Subject: MISALIGNMENT BETWEEN REAR END OF FRONT DOOR GLASS RUN-CHANNEL AND FRONT END OF REAR DOOR GLASS RUN-CHANNEL	Bulletin No.: 09-050/24
	Last Issued : 11/20/2024

2024 CX-90
2025 CX-70

Detail of A

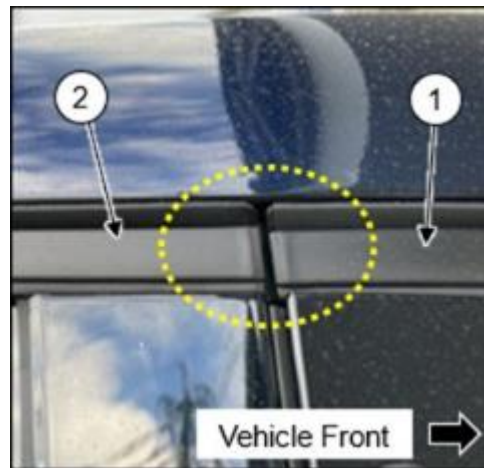
Some vehicles may exhibit misalignment (in any direction) between the rear end of the front door glass run-channel (1) and the front end of the rear door glass run-channel (2).

This may be caused by the rear end of the front door glass run-channel sagging downward due to repeated thermal expansion and external forces. To eliminate this concern, the shape of the clip at the rear end of the front door glass run-channel has been modified to reduce deformation.

1. Verify the customer concern.
2. Replace the front door glass run-channel(s) with a modified one(s) according to the instructions in MGSS.

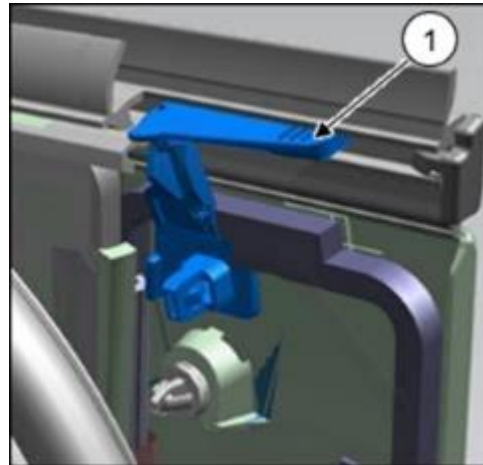
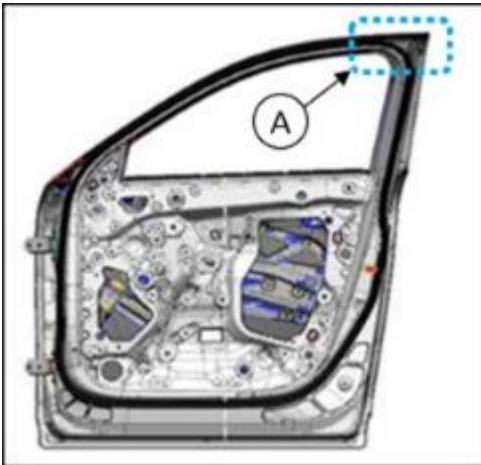
NOTE: The clip is located under a part of the glass run channel. The modified clip (1) installation has been completed in the image.

Install the clip correctly, as shown in the following images.

Section A-A

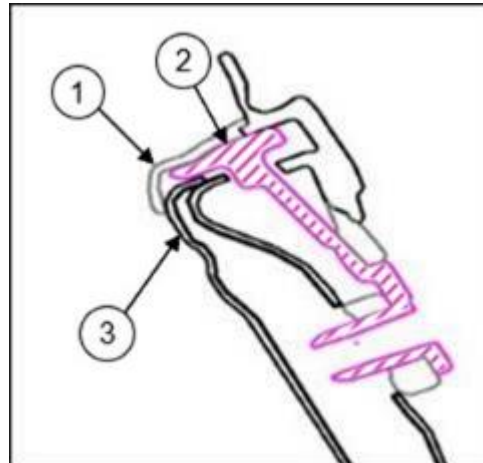
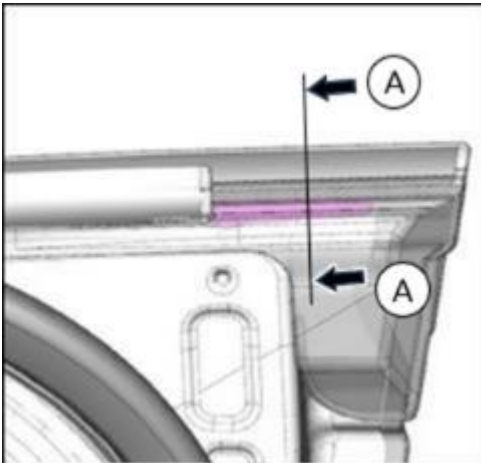
- **Good:** When partially removing the front glass run-channel (1), the clip (2) is visible and installed above the door panel (3).

**Section A-A**

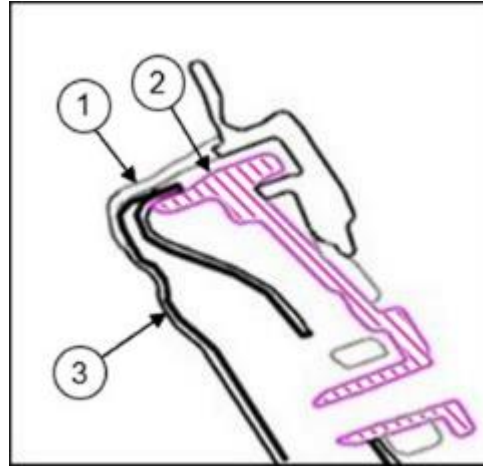
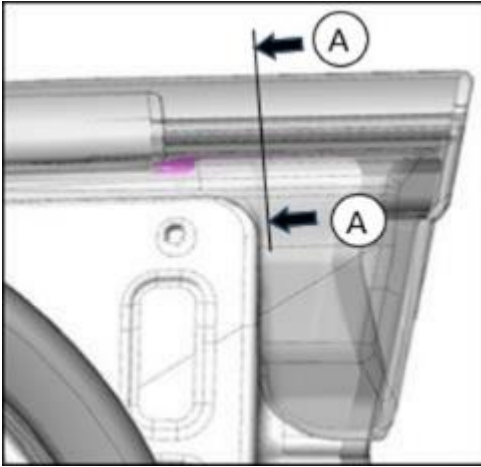
When partially removing the front glass run-channel (1), the clip (2) is NOT completely visible and installed under the door panel (3).
